Date: September 25, 2026
Update Number: P2026-17
Subject: LA400 and LA412 Actuator Arm Resolution
Product Affected: See table below for specific models and affected date codes

Following-up Product Bulletin P2026-16 issued on 9/21/2026 (refer to FAQ's section for a reference), LiftMaster has identified a resolution outlined in the document below. This would address the unexpected error code 32 or 33 observed with LA400 and LA412 actuator arms after install on the subset of units within the date codes listed below.

FIGURE 1 - Remove the brown connector from the main linear actuator arm connector affected units

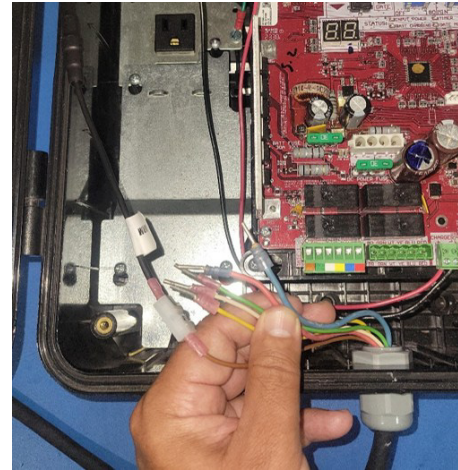
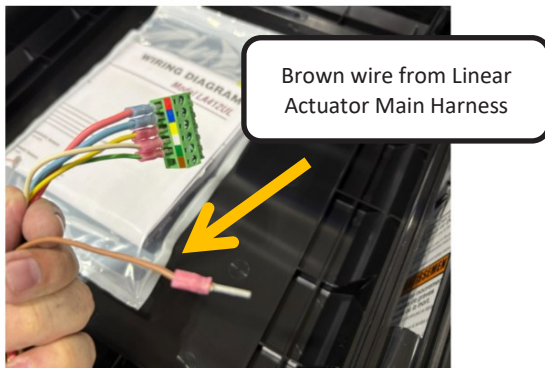
- Confirm that the unit is within the impacted window (**See FAQ**).
- Disconnect power from the operator.
- Remove the cable connector from the control board
- Remove the brown wire from the connector (**FIGURE 1**)
- Take the brown wire from the main linear actuator arm harness and insert it into the connector on the LA400/LA412 Wire Harness Jumper Kit harness (**FIGURE 2**). Note that the field wire harness has two labels – “BR” is on the connector end to connect the brown wire from linear actuator main wire harness. The “BOARD” label is on end to connect to main control board connector actuator input.
- Tighten the screw on the connector and gently tug the connection to confirm it is secure.
- Insert the opposite end of the LA400/LA412 Wire Harness Jumper Kit into the brown wire position on the connector.
- Tighten the connector's screw terminal to secure the wire.

FIGURE 2 - Connect the brown wire to the LA400/LA412 Wire Harness Jumper connector and tighten screw. The label "ARM" is the end that connects to Linear Actuator Main Wire Harness

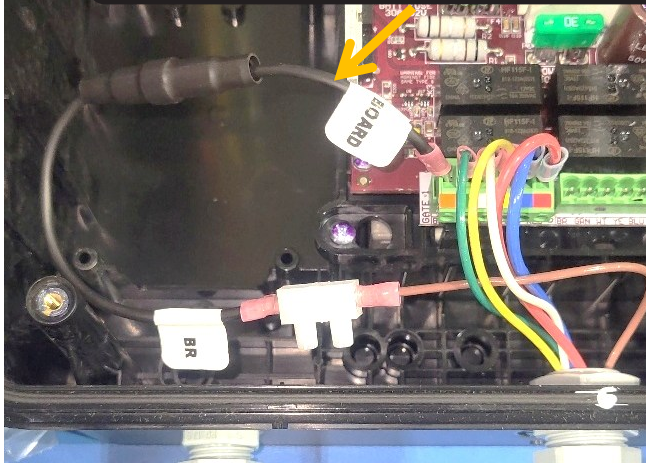
LA400/LA412 Wire Harness Jumper with label "Board" is connected to Actuator Arm Harness
